# City of Santa Fe, New Mexico

Project description . . : ~~ADD OF PORTAL @ E. ELEV;~~ ADD @ SW CORNER *note omitted No 5/22/95*  
 Project number . . . . : 95- 10100071  
 Case Number . . . . . : H-95-71  
 Project type . . . . . : HISTORIC DESIGN REVIEW BOARD  
 Application date . . . : 05/01/95

BOARD ACTION

CASE #H-95-71 ADDRESS 424 San Antonio

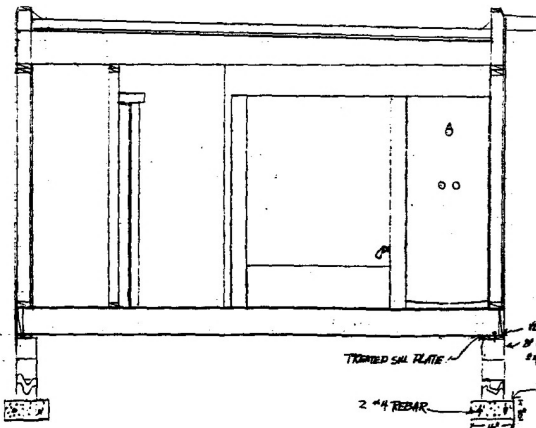
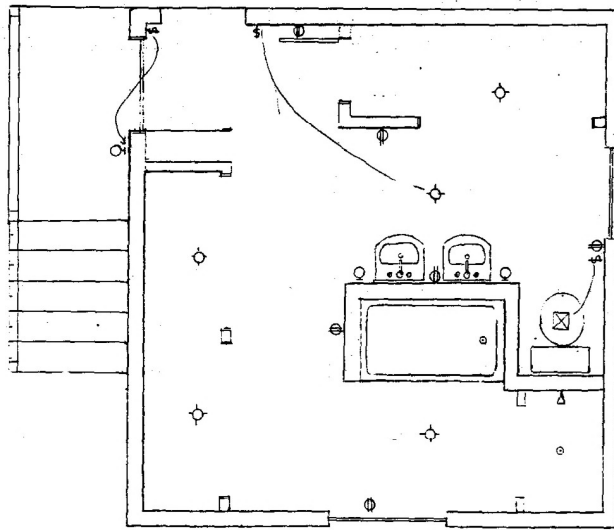
This is to certify that the Historic Design Review Board at its meeting on May 9, 1995, acted on the above referenced case. The decision of the Board was to conditionally approve your request. You shall make part of your Building Permit application any conditions imposed by the Board which are listed as follows: Windows shall have true divided lights, and the steps at the north elevation shall be stucco rather than wood.
